FINAL DESIGN REVIEW
MULTI-PURPOSE SENIOR CENTER
SOLAR HEATING AND HOT WATER SYSTEM

The final design review for the Solar Heating and Hot Water System for the Multi-purpose Senior Center was held on January 23, 1978, at Building 4201 on the Redstone Arsenal. The following personnel were present:

Figure S2. DIRECT SOLAR HEATING SCHEMATIC

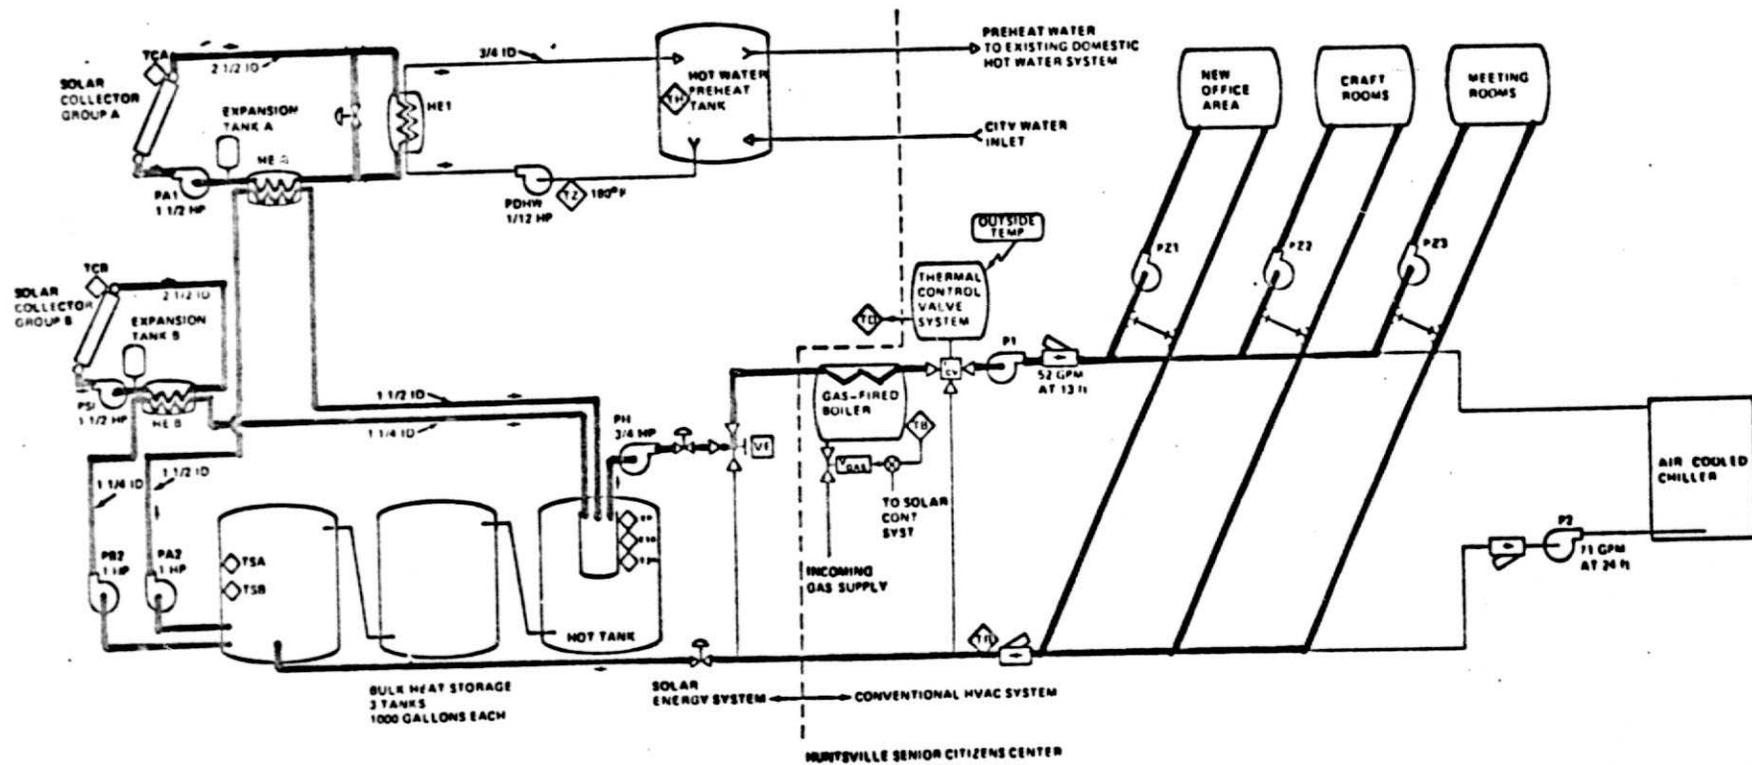
Mr. Novell then discussed the direct solar heating schematic. Mr. Weinstein asked if the unit heaters were oversized. Mr. Novell stated that he did not think so; they are designed to use 120-140° water. Mr. Novell stressed the fact that each room was individually heated. Mr. Weinstein stated that as the system presently is, when a room is not occupied it is still being heated. He suggested that this problem be eliminated by wiring it so when the lights are turned off the room goes on a night set-back system. Mr. Lewis said that this could be done any time in the future. Mr. Lewis asked why we had electrical resistance heaters in the unit instead of just using the boiler when solar can not heat the room. Mr. Novell stated that these were only in the perimeter rooms. Mr. Lewis then asked if we were worried about our gas being turned off. Mr. Wallace told him we were not; the Senior Center is on permanent service. Mr. Wiesenmaier stated that it seemed this was going to be a fairly lengthy trial and error situation. He asked if there was a defined acceptance test that will be used. Mr. Davidson stated that the acceptance test of the solar system was supposed to be a separate item. However, a draft acceptance test was to be presented at the final review. Mr. Wessels stated that they felt it was their (the contractors and the City) responsibility to see that the system meets the acceptance test; however, he added that he needed a little guidance in drawing up an acceptance test. Mr. Davidson stated that he had a draft of what he thought should be in the test and he would be glad to give him a copy of it.

Figure S3. SOLAR DOMESTIC WATER HEATING SCHEMATIC

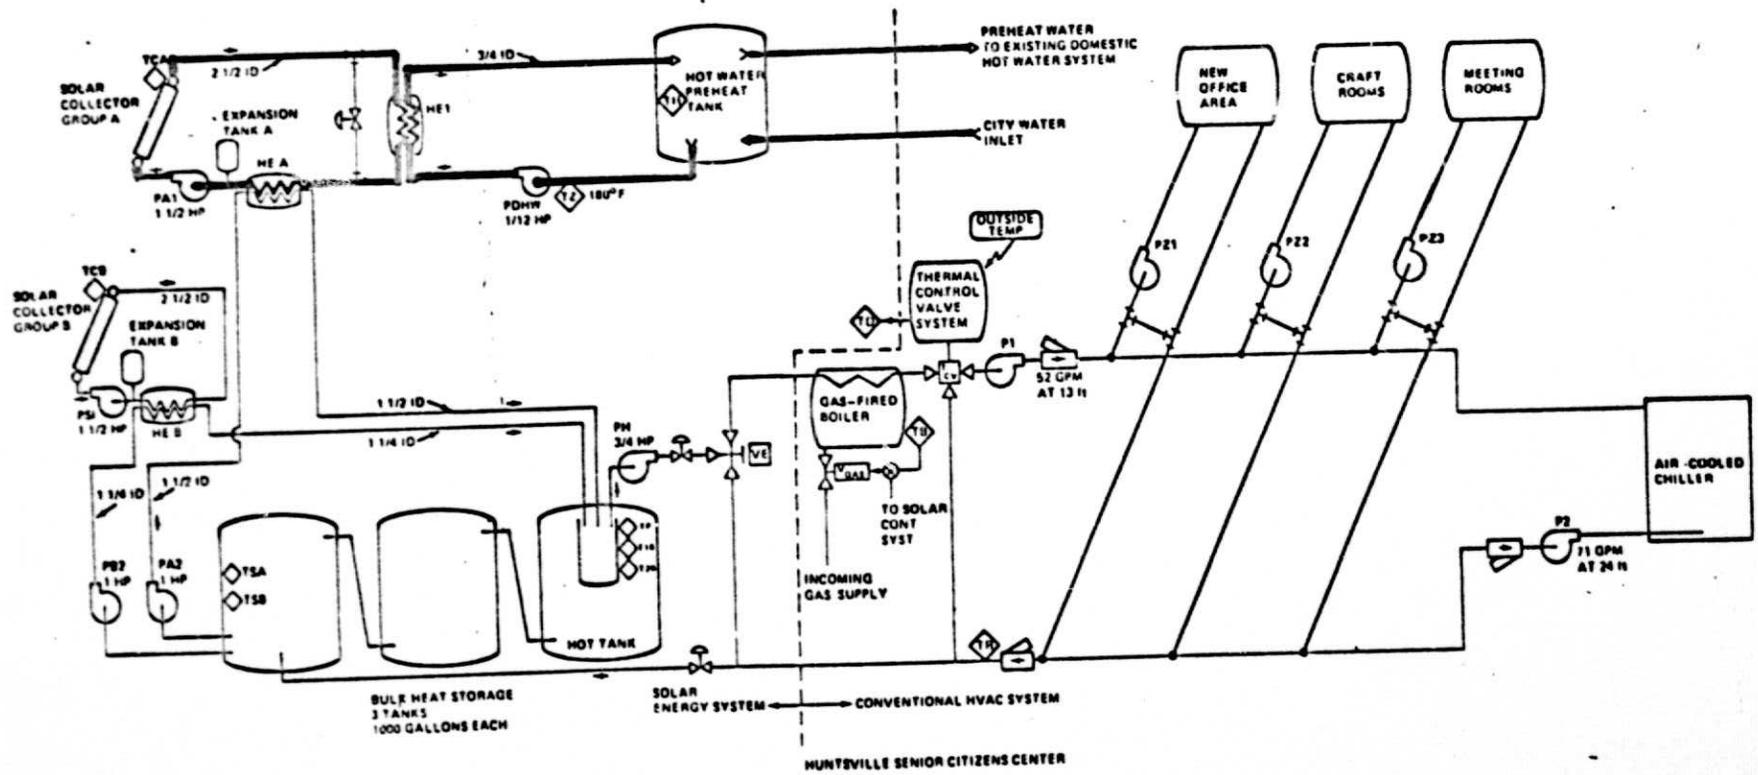
Mr. Novell then discussed the domestic water heating schematic. Mr. Easterly suggested placing a 5-minute delay on the two pumps in this cycle. Mr. Lewis asked what the back-up system for the water heating and the building heating is. Mr. Novell told him that both were gas. Mr. Lewis asked what the domestic hot water storage tank was sized for. Mr. Novell told him that it was a 120 gallon tank and that is about $\frac{1}{2}$ day's load. However, the building is occupied during the day when the solar panels are collecting so basically it will be an operating storage tank. Mr. Lewis suggested if the temperature is allowed to build up and a tempering valve is used, there could be maybe three days supply. Mr. Novell agreed that a tempering valve would be a good addition to the system.

Figure S4. HEATING FROM STORAGE SCHEMATIC

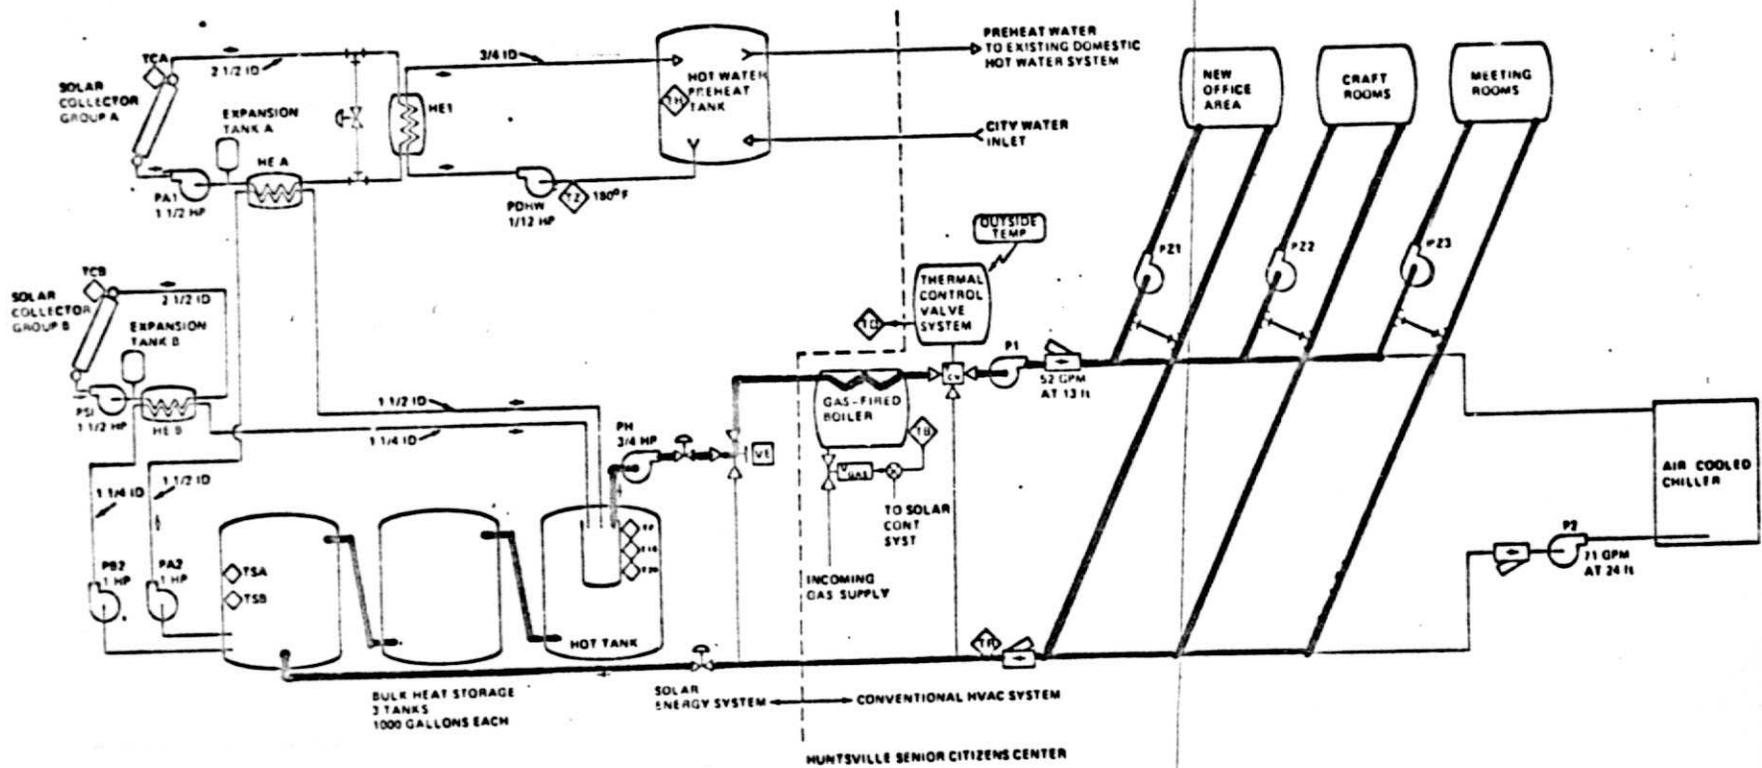
Mr. Novell then covered the heating from storage schematic. Mr. Easterly asked if there was enough piping above the storage tanks to cause a back-flow problem. Mr. Novell stated that he did not know that there was; but it is a possibility. Mr. Davidson then stated that in New Orleans it was suggested that we go from the one 3-way valve to two 2-way valves. Mr. Novell said he had looked into that possibility and he felt that the 3-way valve would work just as well if not better.

Figure S5. STORE SOLAR HEAT SCHEMATIC

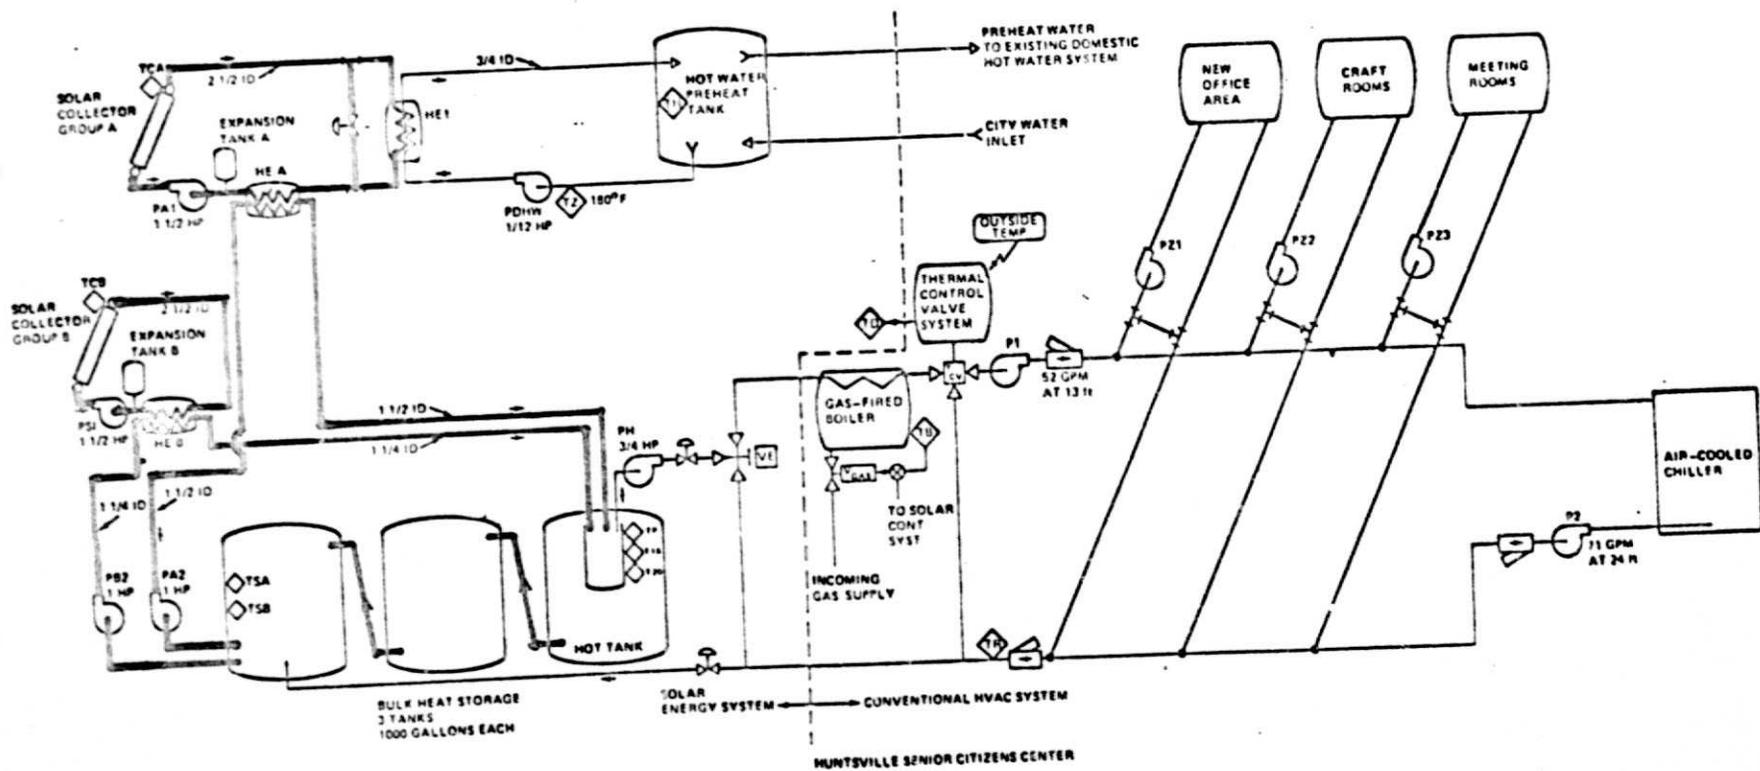
There was then some discussion as to the method used for filling the system with oil. Mr. Novell covered the procedure for filling the system and eliminating any air in the system. There were no questions on this procedure. Mr. Novell then covered the storage schematic. Mr. Lewis asked if the storage tanks were flooded. Mr. Novell stated that they were vented at the top but basically they were flooded tanks. There was some discussion as to the characteristics of silicone oil, for example, it does not deteriorate & it is non-toxic. Mr. Easterly asked if the pump seals were a problem. Mr. Novell stated that the pump they are using is the best pump they know of. Mr. Easterly asked if the pump had to be worked on, is

there a convenient holding tank. Mr. Novell said there was not; however he felt that was a good idea and would check into it. Mr. Lewis asked if the pumps in the lower array could be elevated to place a pan under them. Mr. Novell assured him that they could.
